ADDENDUM NUMBER ONE (1)

Project: #209-578
Gross Anatomy Phase III
DA PN: 22003
(UMMC Bid # 3700)

FROM: Dean Architecture, P.A.
661 Sunnybrook Road, Suite 140
Ridgeland, MS 39157
(601) 939-7717

TYPICAL SPLICE DETAIL
1" = 1'-0"

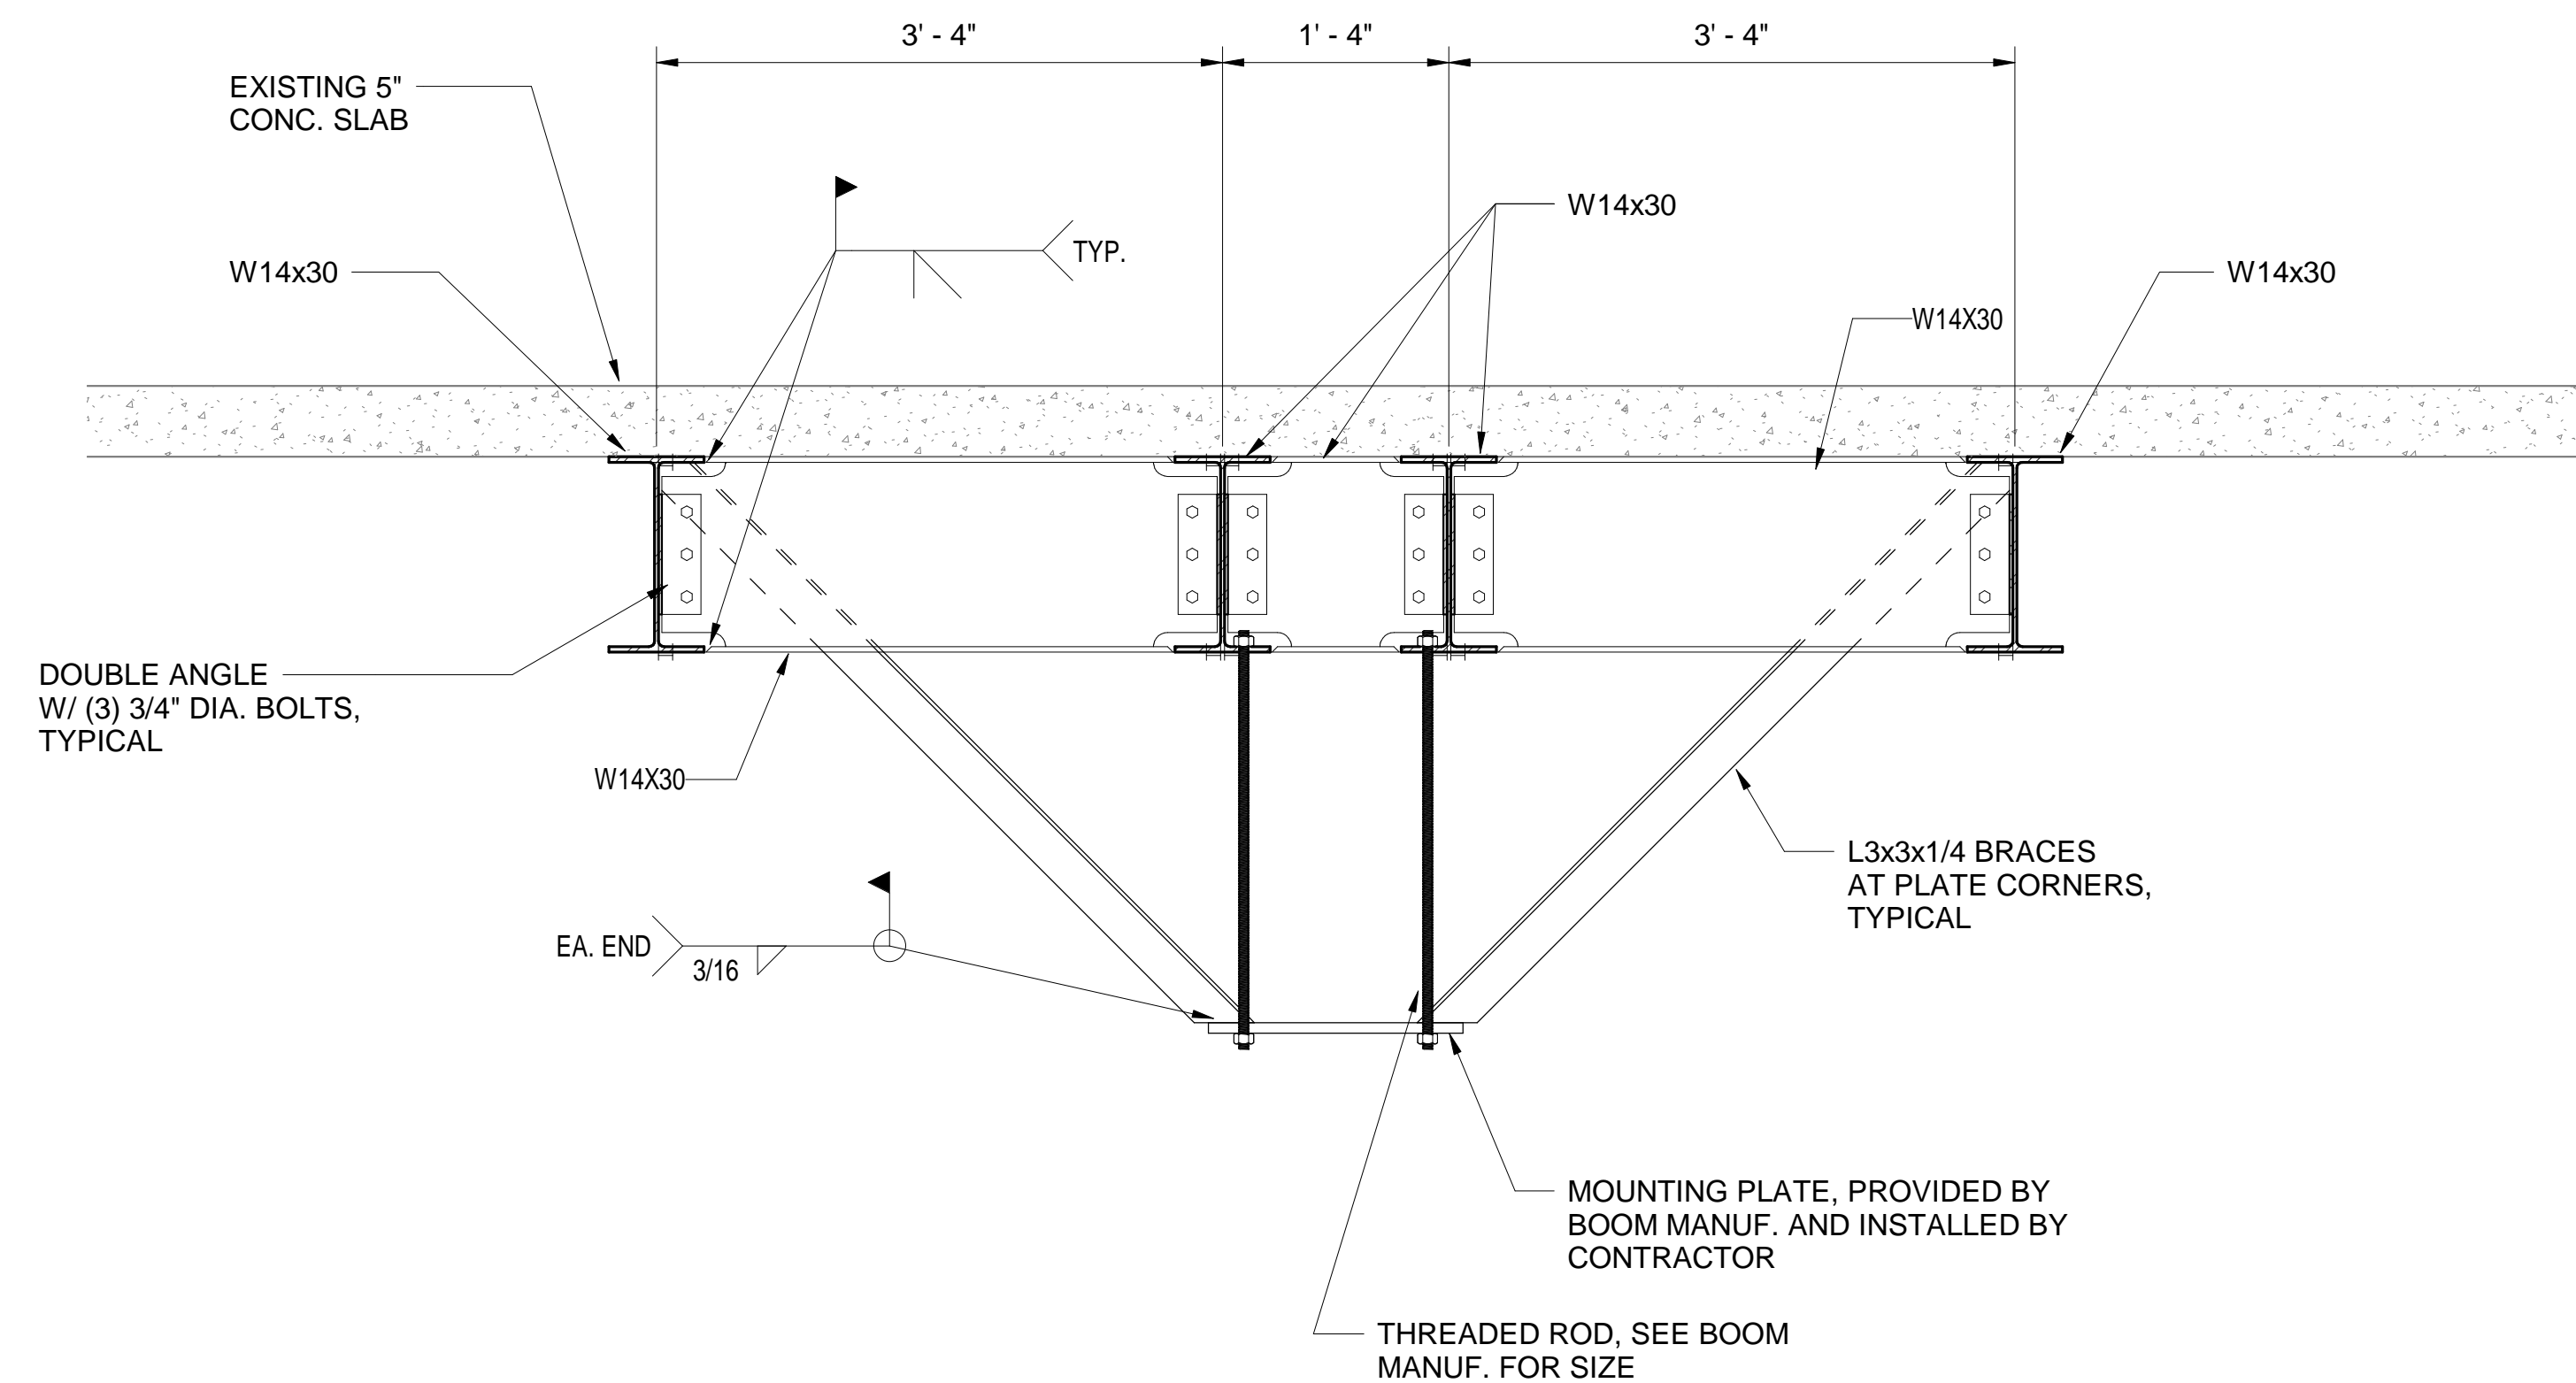
- Item #1:** Sheet A101; Partition Type "F"; Amend entire "MASONRY NOTE" to read as follows:
MASONRY NOTE: WHERE EXISTING DOOR OPENINGS ARE INFILLED, PROVIDE 4"x8"x16" CMU, MORTAR/GROUT AND REINFORCEMENT/ANCHORAGE AS SPECIFIED IN SECTION 042000.
- Item #2:** Replace Sheet S100 with attached S100 Rev.pdf. This revised drawing includes a Typical Splice Detail for Structural Steel Beams.
